GLAST Large Area Telescope

LAT MRB for ACD FREE Board

NASA Goddard Space Flight Center
Laboratory for High Energy Astrophysics

Schematic of Proposed Fix

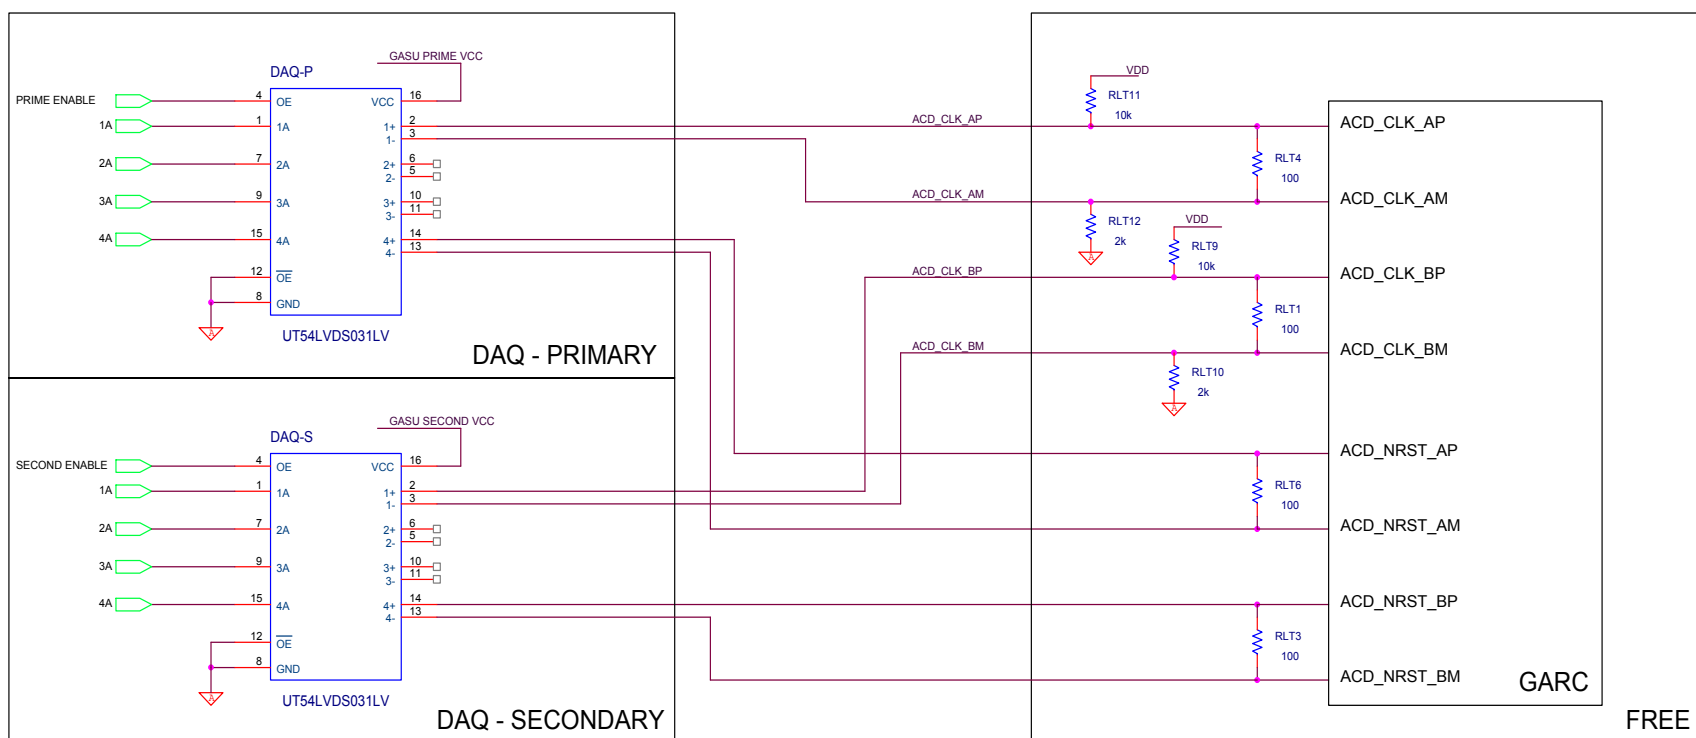
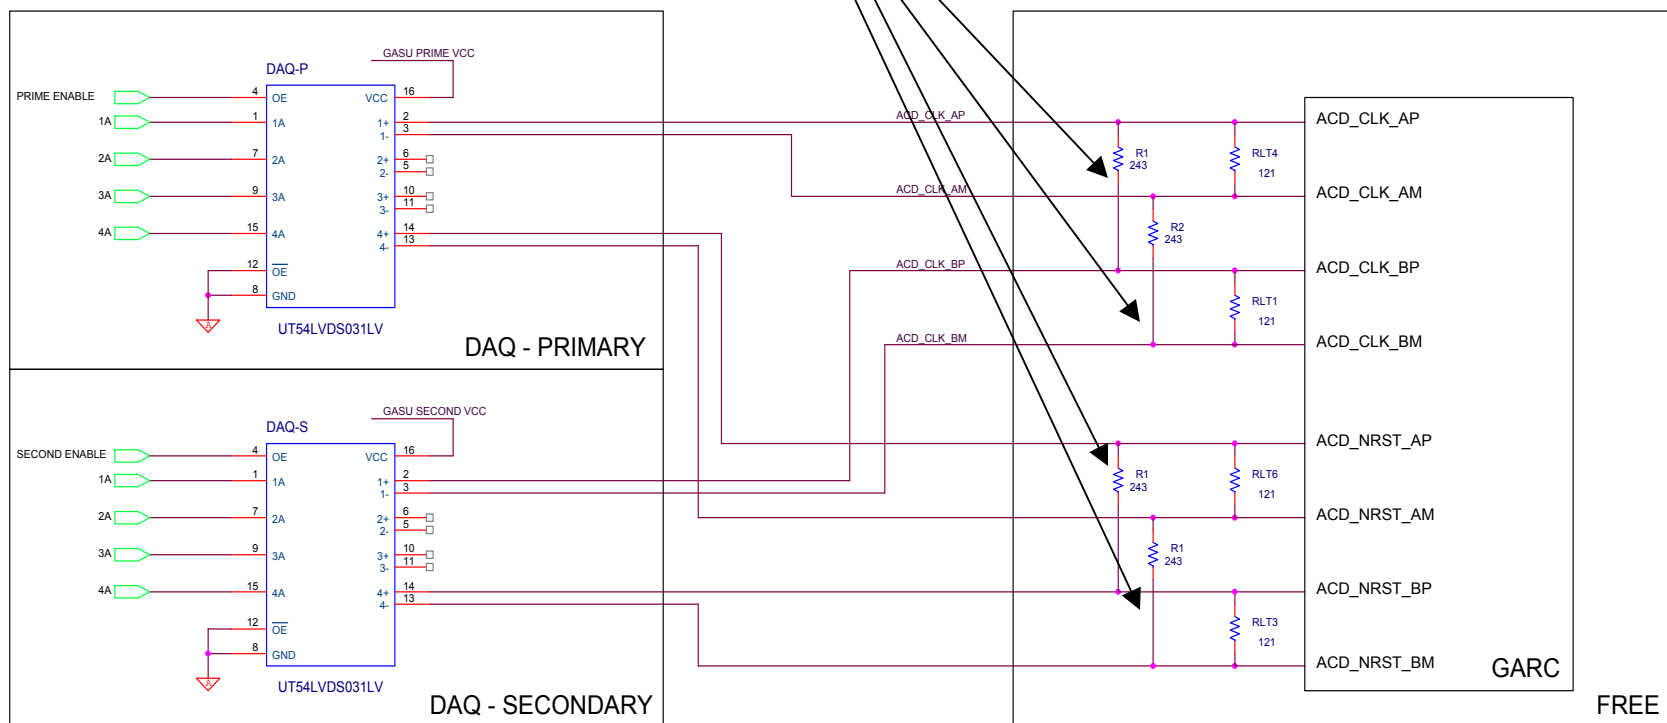
The proposed modification involves cross-strapping the clock and reset inputs to allow a portion of the transmitted signal to be seen by both sets of receivers. The circuit as it presently exists on the FREE card is shown below

The 243 ohm resistors show the cross-strapping between the receiver pairs

The proposed change is to be made on both the clock and the reset signal paths. If both the primary and redundant clock receivers can be active, it is necessary to ensure the reset level is held inactive.

Impedance Calculation

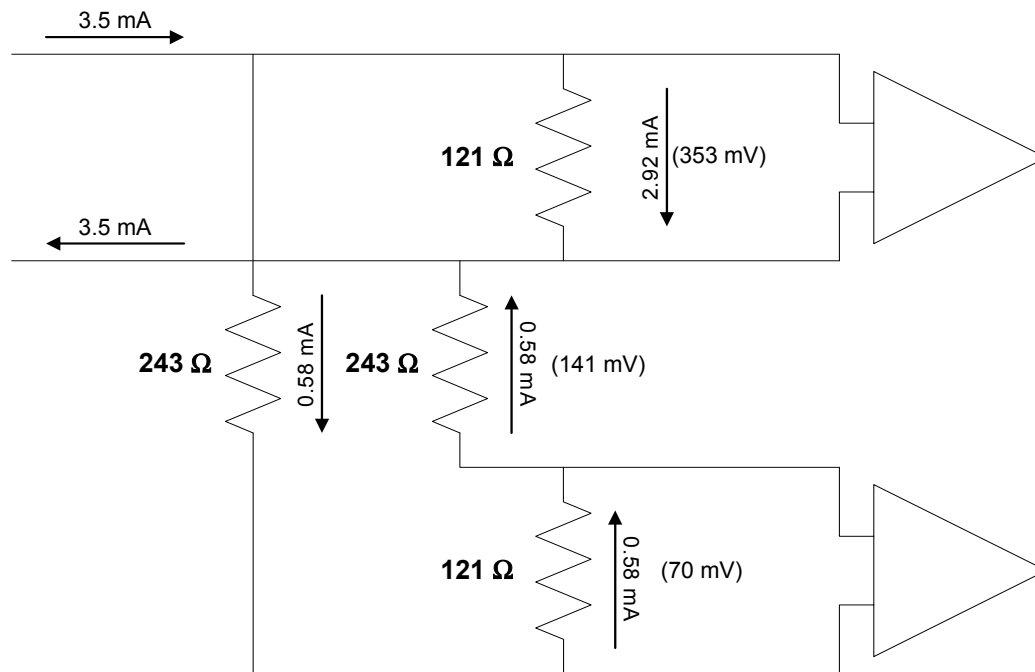
Total termination impedance using the 121 Ω resistors at the receiver inputs and the 243 Ω cross-strapping resistors is:

$$Z = \frac{(121)(243 + 121 + 243)}{121 + 243 + 121 + 243} = 100.9\Omega$$

which is close to the desired 100 Ω termination.

Test Results - Signals at the Unpowered Receiver

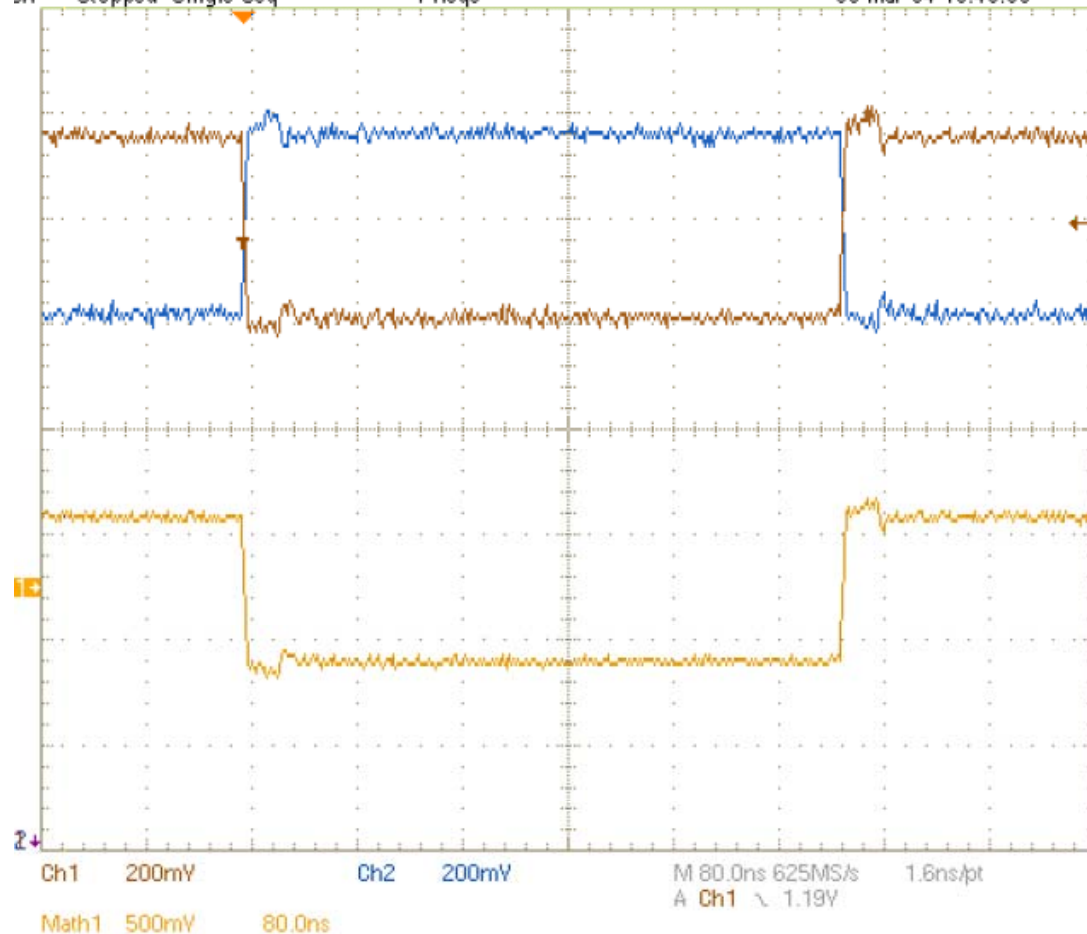
**Unpowered receiver, 20 MHz.
Implementation has no margin at 20 MHz as tested.**

- Cabling reflections from the unterminated, unpowered driver side are quite significant with flight length cables.
- **At the nominal 20 MHz clock rate, this fix does not function reliably.**
- LAT Electronics has agreed to configure the GASU to drop the clock rate to approximately 1.25 MHz for 1 second at FREE board turn on to mitigate this problem.
- At the 1.25 MHz rate, the reflections do not hinder operation and the FREE card redundant (unpowered) receiver will receive clocks reliably (which is the goal of this modification).
- After 1 second, LAT will command the GASU to return the FREE card clock to the nominal 20 MHz rate for operations.

Test Results - Unpowered Receiver at 1MHz Clock

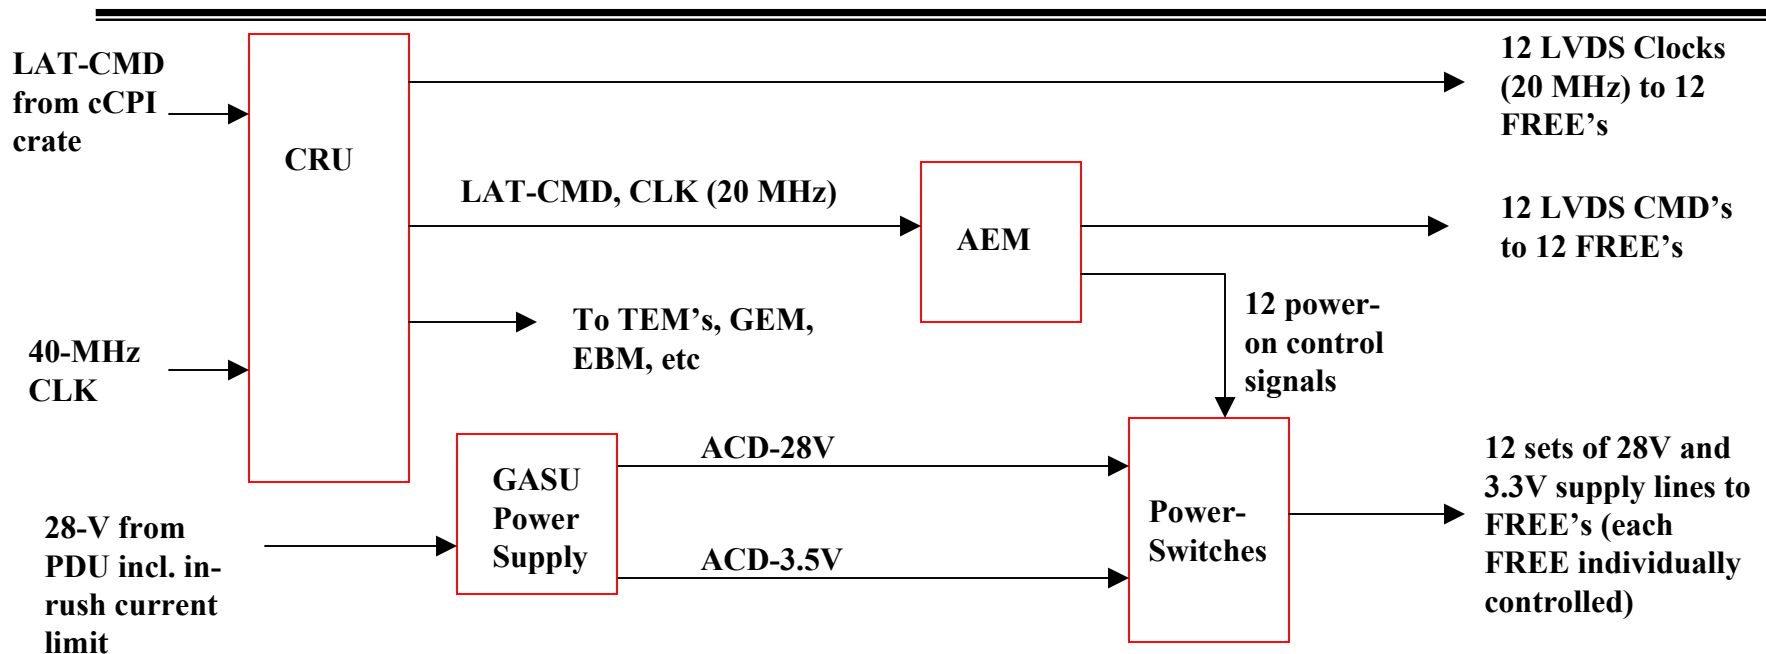
Unpowered receiver, 1 MHz, Differential signal is ~ 150 mV

New Design of DAQ-GASU

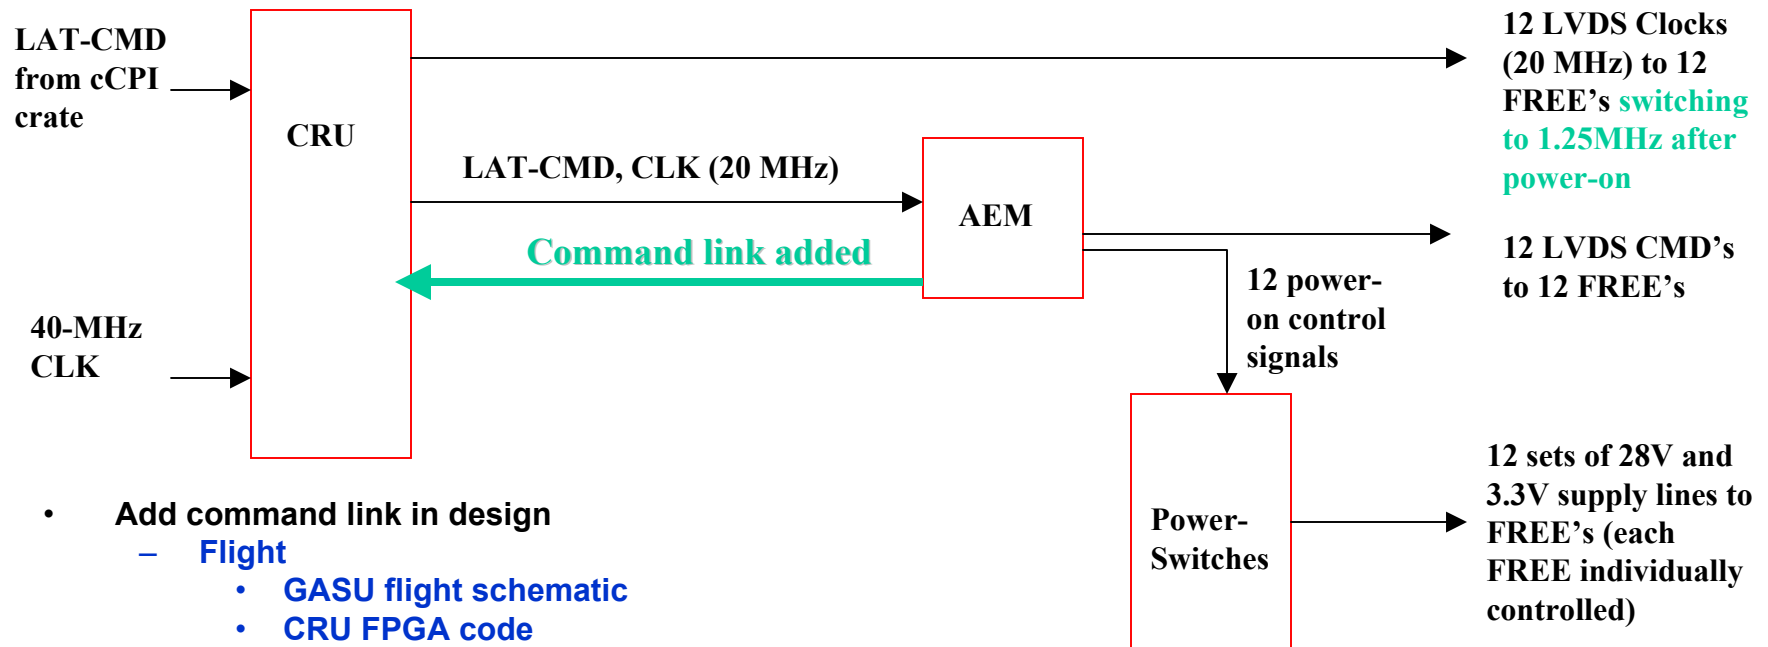
- **Add command link in design**
 - **Flight**
 - GASU flight schematic
 - CRU FPGA code
 - AEM FPGA code
 - **G3 test-stand**
 - Add wires on G3-GASU board
 - Modify CRU and AEM FPGA code
 - Modify software for AEM register control
- **Need to see how to test since 1.25MHz clock is only temporary and effect on FREE can not be "read-back"**
- **Question of**
 - "hard-wire" 1-sec 1.25Mhz duration only at power-up
 - Add register in AEM to select frequency independent of power-up

- **Switch FREE clock frequency from nominal 20-MHz to 1.25 MHz for about 1-sec following power-on to FREE**
- **Problem**
 - **Clock comes from CRU**
 - **Only AEM knows when FREE's are powered**
- **Preferred Solution**
 - **Add path from AEM to CRU to communicate power-on transition**
 - **Can't use already available 12-FREE power-on signals on board (digital contamination of signals to base of power-on pnp-transistors resulting in cross-talk into AEM 3.3V voltage), plus need 12 additional pins on CRU**
 - **Implement as serial command connection from AEM to CRU**
